FIA FORMULA 1 WORLD CHAMPIONSHIP

2026 BAHRAIN GRAND PRIX IN MALAYSIA

From	The FIA Formula 1 Media Delegate	Document	12
To	All Teams, All Officials	Date	02 October 2026
		Time	10:03

Title Car Presentation Submissions

Car Presentation – Bahrain Grand Prix McLaren Mastercard F1 Team

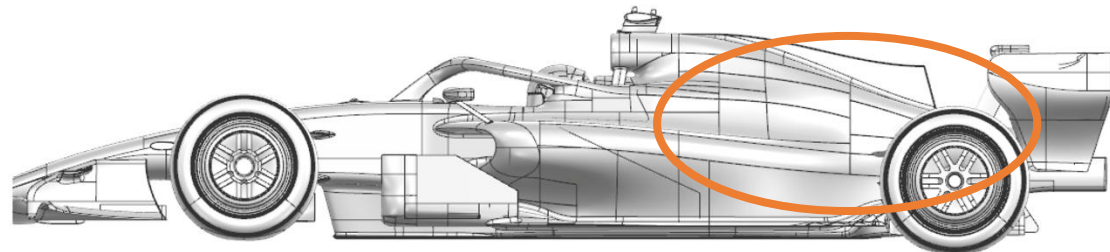
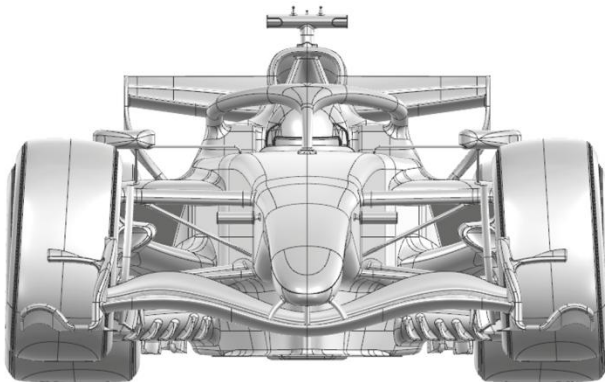
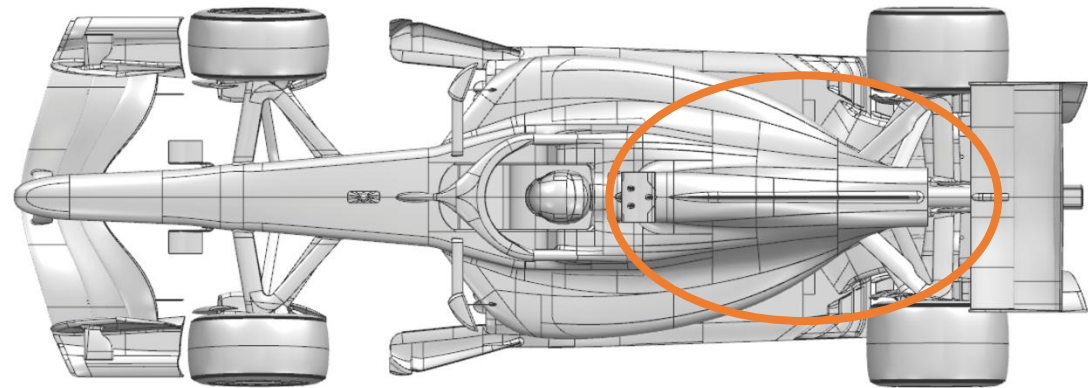
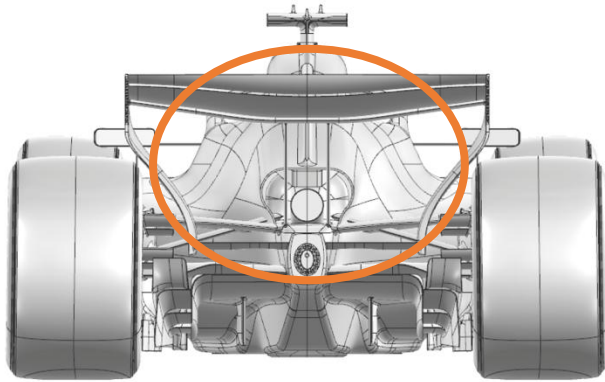
Updated component	Primary reason for update	Geometric differences compared to previous version	Brief description on how the update works (min 20, max 100 words)
1	Coke/Engine Cover	Circuit specific - Cooling Range	High Cooling Bodywork	To meet the high cooling demands of this and the upcoming circuits, a new engine cover aiming at increased cooling massflow has been designed.

Mercedes-AMG PETRONAS F1 Team

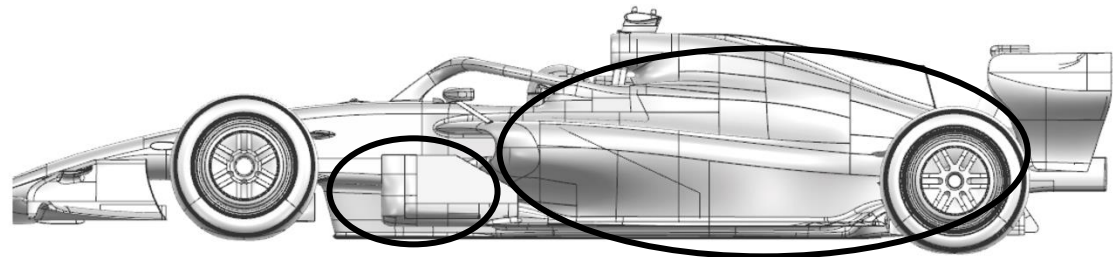
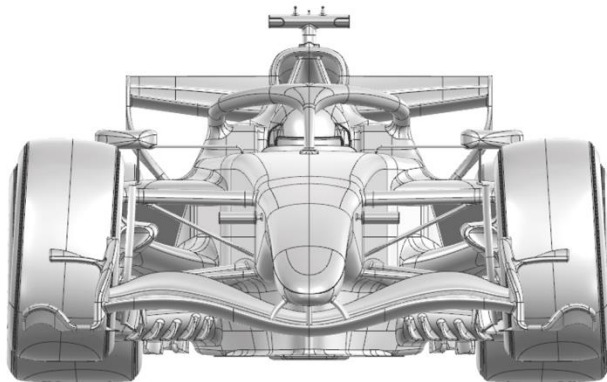
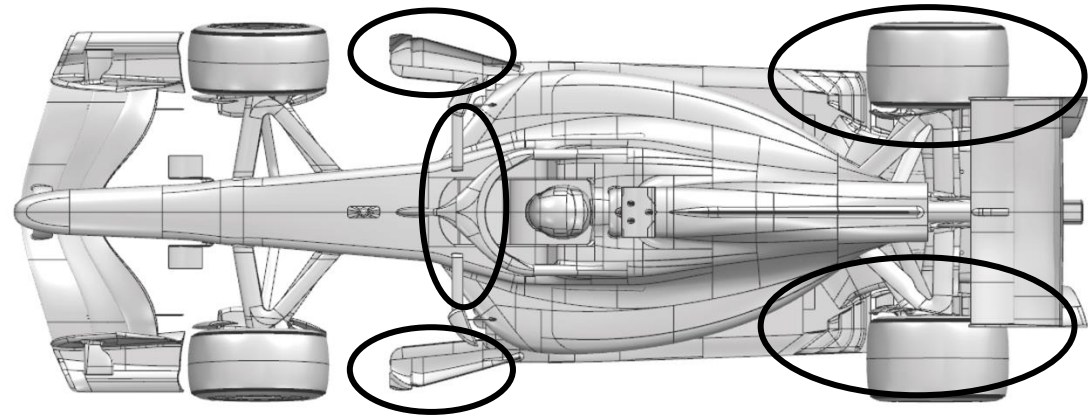
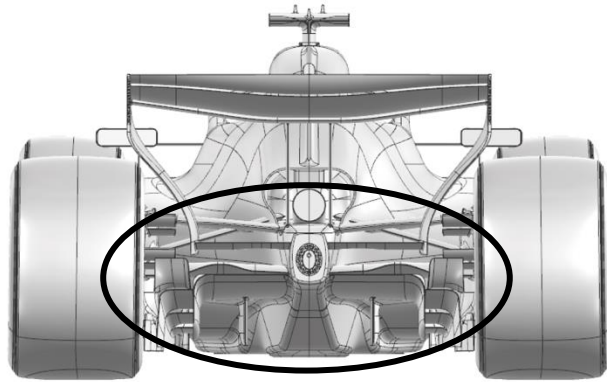
Updated component	Primary reason for update	Geometric differences compared to previous version	Brief description on how the update works (min 20, max 100 words)
1	Floor Board	Performance – Local Load	Reprofiled horizontal elements, and vertical slotted upper element added.	Reprofiled elements and new vertical elements added to improve local pressure distribution, reduce separations at the extremes of the operating envelope, and improve flow to the rear of the car, resulting in increased load.
2	Floor Leading Edge	Performance - Flow Conditioning	Reprofiled and additional down-washing elements added.	Additional down-washing elements increase local load and outwash, improving flow to the rear of the car and increasing rear floor load.
3	Floor Corner	Performance - Flow Conditioning	Additional slots and reprofiled elements.	Re-optimisation of floor corner slot arrangement to both increase local load and to also improve flow into the diffuser and hence rear load.

4	Floor Body	Performance – Local Load	Reprofiled diffuser roof, sidewall, and winglet.	Through re-optimisation of the diffuser roof and sidewall we have increased local load and improved robustness throughout the operating envelope.
5	Rear Suspension	Performance – Local Load	Reprofiled suspension fairings.	Track rod and driveshaft camber re-distributed to increase local load whilst improving coupling with diffuser winglet and rear drum furniture.
6	Rear Corner	Performance – Local Load	Rear winglet span and position change.	Chord and position of the rear drum winglets re-optimised to work with above fairing update and to improve rear tyre wake control across the operating envelope.
7	Rear Bodywork	Performance - Flow Conditioning	Reduce volume, increased sideview ramp.	Reduce volume and increased sideview ramp increases downwash to the rear floor and rear drum, resulting in more load.

Car Presentation – Bahrain (Sepang) Grand Prix Oracle Red Bull Racing

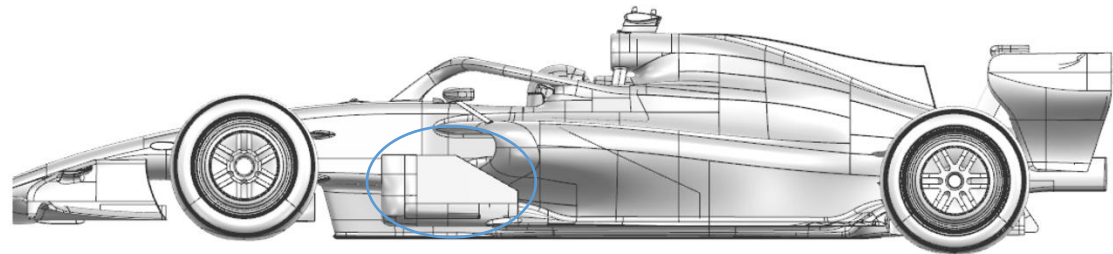
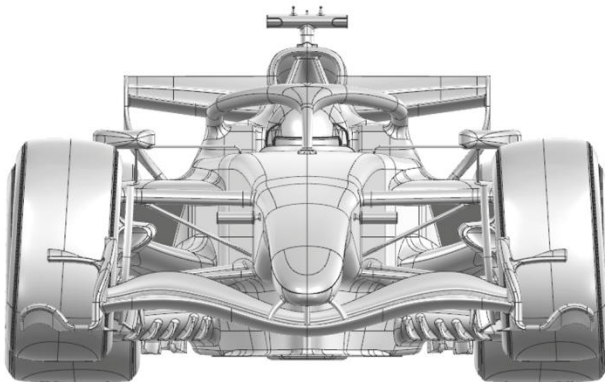
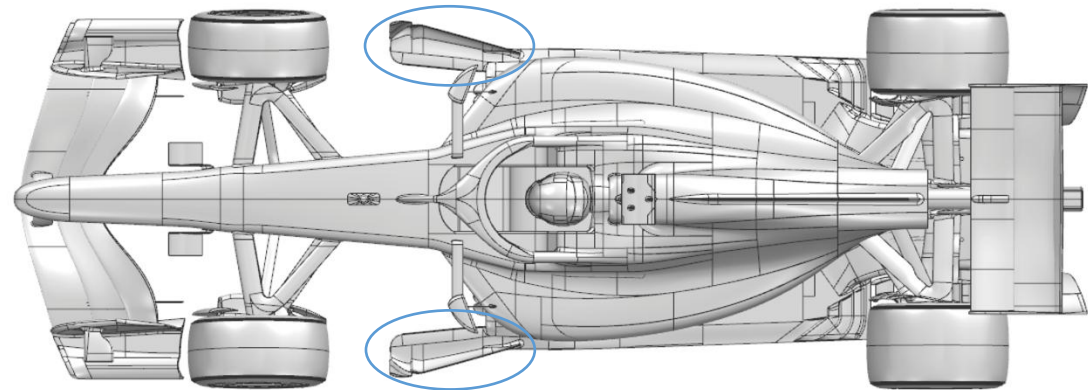
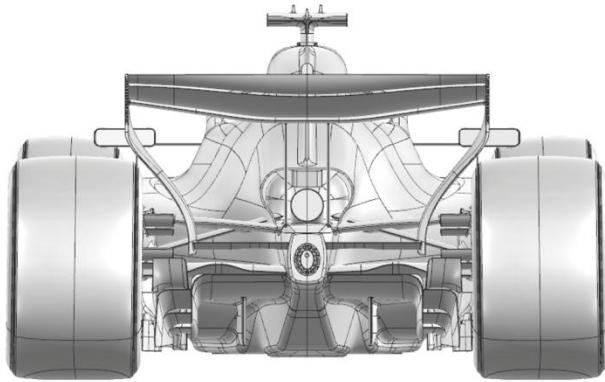
Updated component	Primary reason for update	Geometric differences compared to previous version	Brief description on how the update works (min 20, max 100 words)
1	Floor Board	Performance - Local Load	Revised Floor Board geometry	Applied above the existing floor foot geometry, the new board realises development work to extract more load locally whilst maintaining flow stability behind the front tyres.

Car Presentation – Bahrain Grand Prix Scuderia Ferrari HP

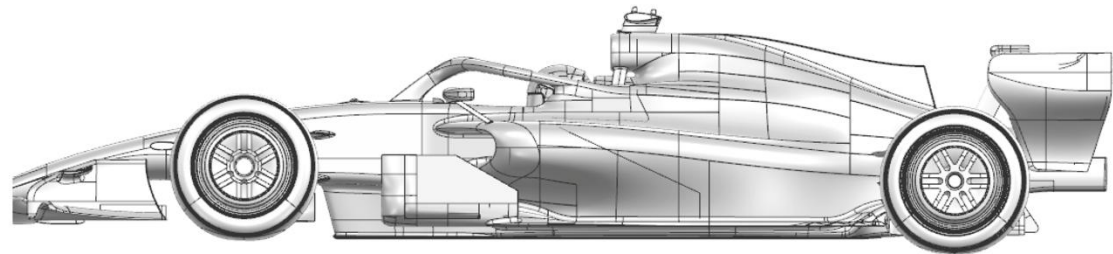
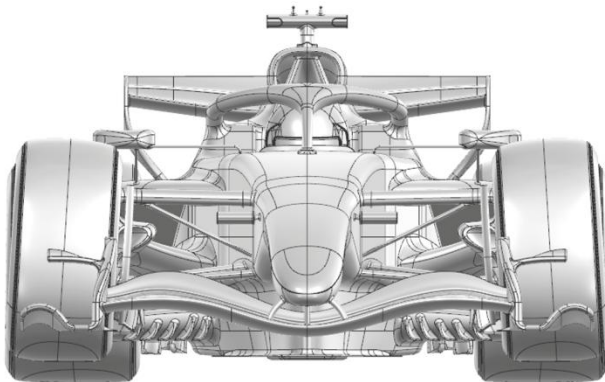
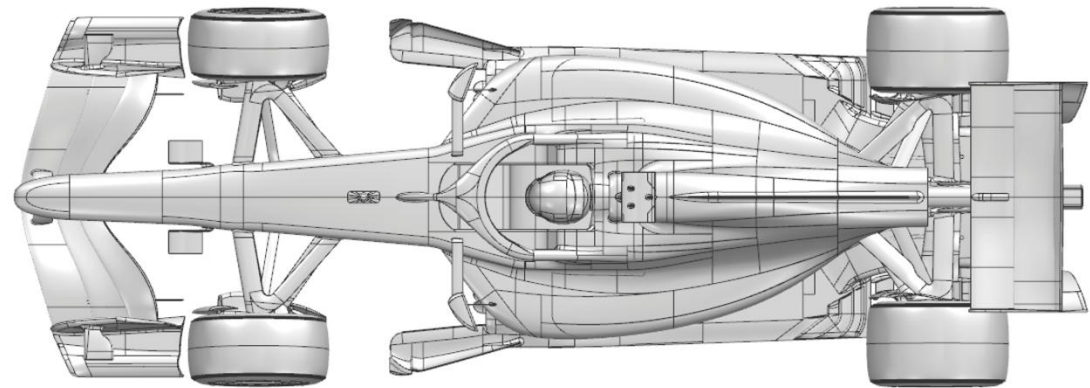
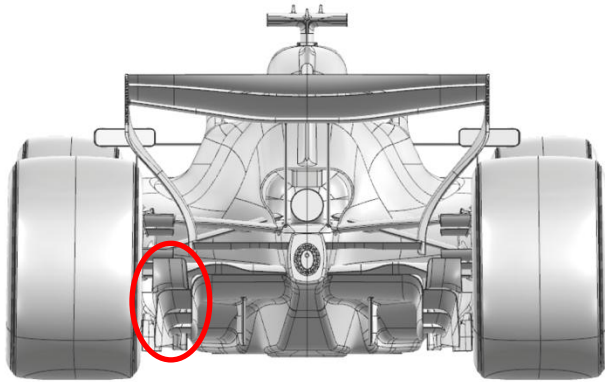
Updated component	Primary reason for update	Geometric differences compared to previous version	Brief description on how the update works (min 20, max 100 words)
1	Diffuser	Performance - Local Load	Diffuser outboard winglet cascade element development	Not Sepang track specific, this very localized development around the diffuser winglet cascade is providing a favourable additional downforce across the entire car operating envelope

Visa Cash App Racing Bulls

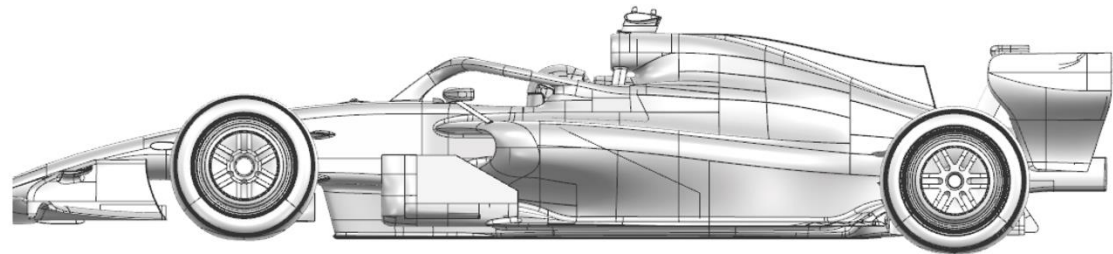
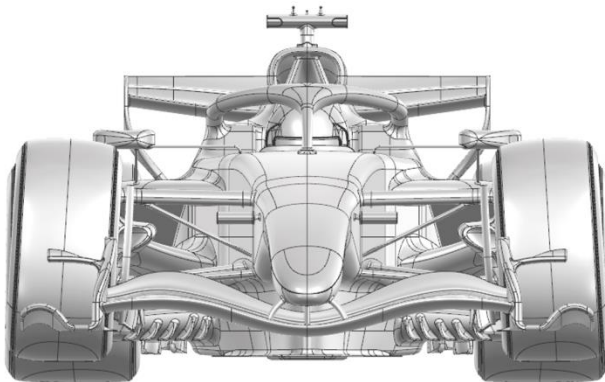
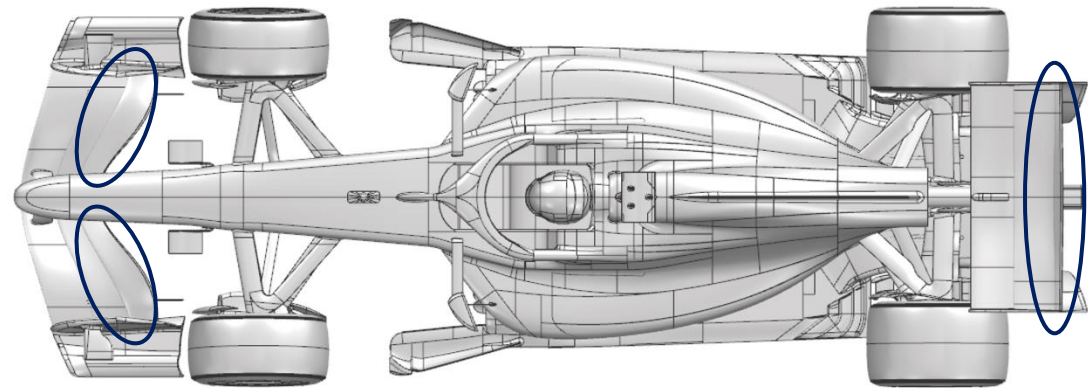
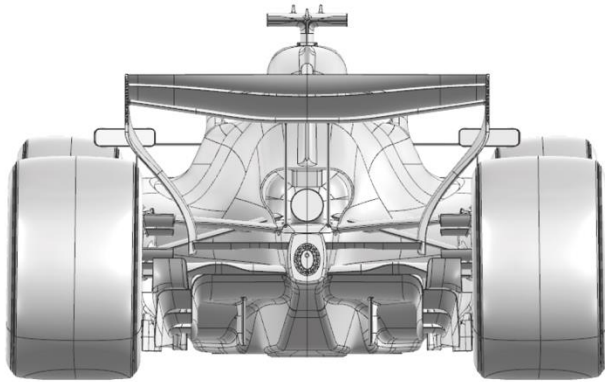
Updated component	Primary reason for update	Geometric differences compared to previous version	Brief description on how the update works (min 20, max 100 words)
1	Front Wing	Circuit specific - Balance Range	New front flap	A longer chord flap for the front wing that was introduced at the previous event increases the load that can be generated by the wing, meeting the aero balance requirements for this circuit.
2	Rear Wing	Performance - Local Load	Revised rear wing auxiliary components	An improved design of the rear wing support components allows the rear wing to perform more effectively, increasing the efficiency of load generated.

TGR HAAS F1 TEAM

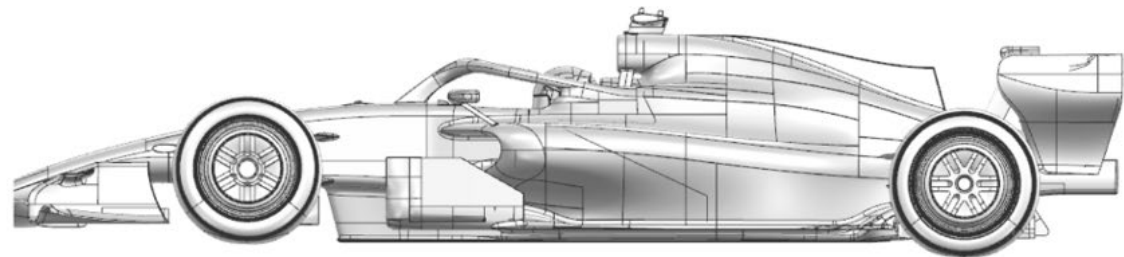
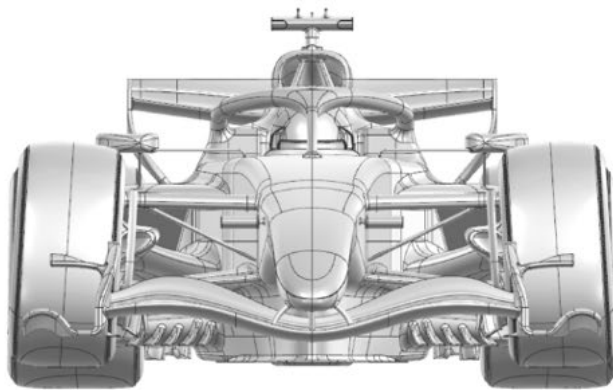
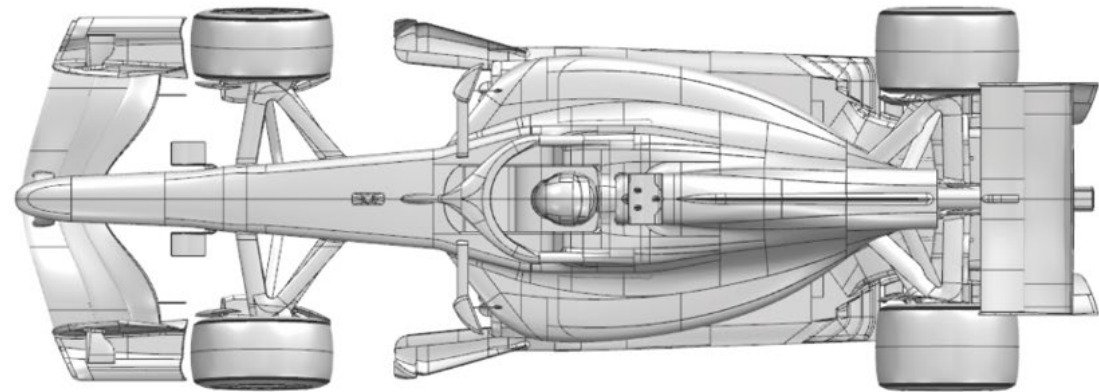
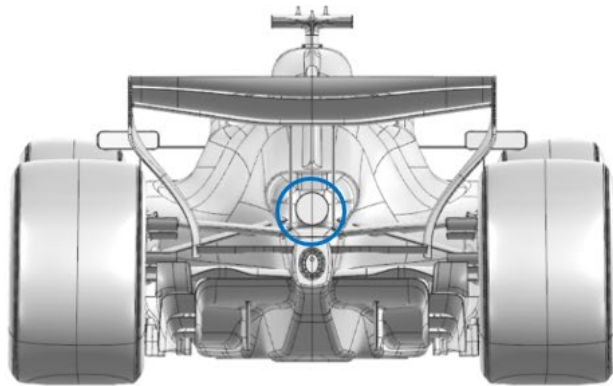
Updated component	Primary reason for update	Geometric differences compared to previous version	Brief description on how the update works (min 20, max 100 words)
1	Rear Impact Structure	Performance – Local Load	Updated Rear Impact Structure geometry	An additional Rear Impact Structure device will be available on track, enabling targeted tuning of the car's characteristics for this circuit.

BWT Alpine F1 Team

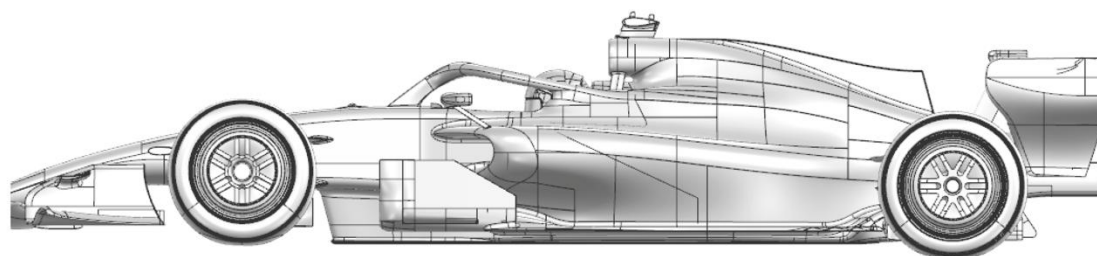
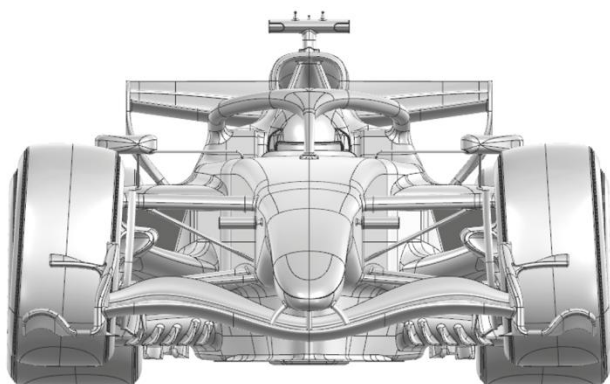
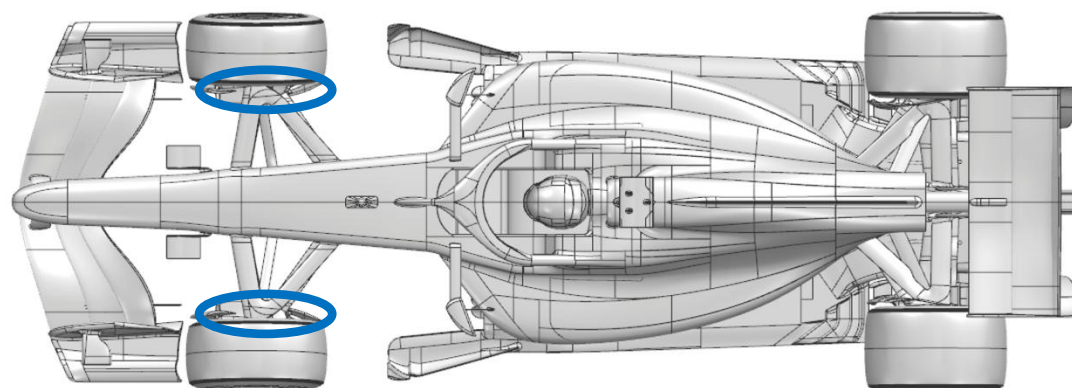
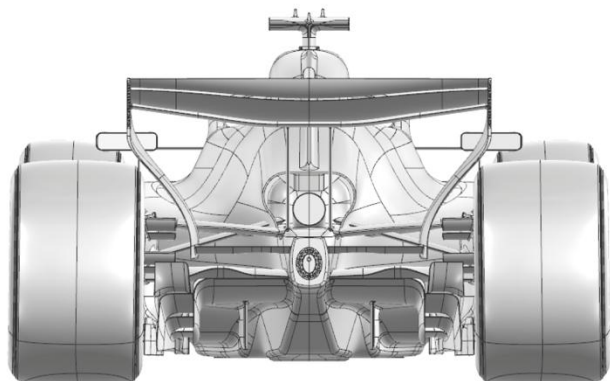
Updated component	Primary reason for update	Geometric differences compared to previous version	Brief description on how the update works (min 20, max 100 words)
1	Front Corner	Performance – Brake Cooling	Revised front drum exit	The front drum exit has been trimmed to increase brake cooling capacity, improving thermal management for the upcoming high-demand tracks.
